Access Compliance Report

Public Rights-of-Way

(Curb Ramps)

Intersection ID: 14294	Main Street: EAST_BV	Cross Street: EUCLID_AV	Location: E
ADA ID: 2760135E2F95	Ramp Type: Directional1	Initial Pass/Fail: Pass	Overall Compliance: No
		Severity Score: 0

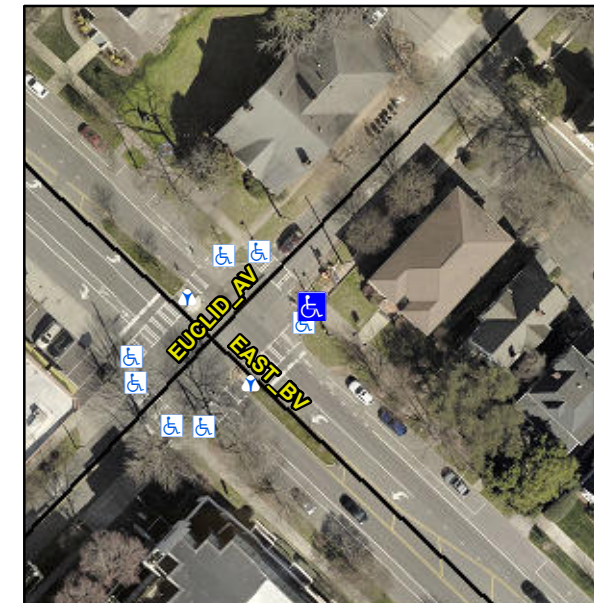
R304.5.3

Compliance	Description	Data	Compliance	Description	Data
N/A	Ramp Length (in)	46.0	Yes	Grade Break?	Yes
Yes	Ramp Width (in)	72.0	Yes	Grade Break Slope (%)	4.8
Yes	Ramp Slope (%)	5.0	No	Grade Break XSlope (%)	2.1
Yes	Ramp XSlope (%)	1.4			
Yes	Flare Type LT	N/A	Yes	Flare Type RT	N/A
N/A	Flare Slope LT (%)	N/A	N/A	Flare Slope RT (%)	N/A
N/A	Flare Traversable LT?	No	N/A	Flare Traversable RT?	No
Yes	Landing Length (in)	82.0	Yes	DWS Provided?	Yes
Yes	Landing Width (in)	72.0	Yes	DWS Contrast?	Yes
Yes	Landing Slope (%)	0.8	Yes	DWS Length (in)	25.0
Yes	Landing X Slope (%)	0.6	Yes	DWS Full Width?	Yes
N/A	Landing Curb? (Y/N)	No	Yes	DWS Offset LT (in)	17.0
N/A	Shared Landing?	No	Yes	DWS Offset RT (in)	0.0
Yes	Gutter Ponding?	No	Yes	Gutter Slope (%)	2.1
Yes	Gutter Lip Ht (in)	0.0	Yes	Gutter X Slope (%)	0.1
N/A	Painted X Walk1?	Yes		Road Slope (%)	3.2
	X Walk 1 Direction	To NW		Road X Slope (%)	0.8
	X Walk 1 Width (in)	110.0		Clear Space?	Yes

Remove & Replace Entire Ramp.
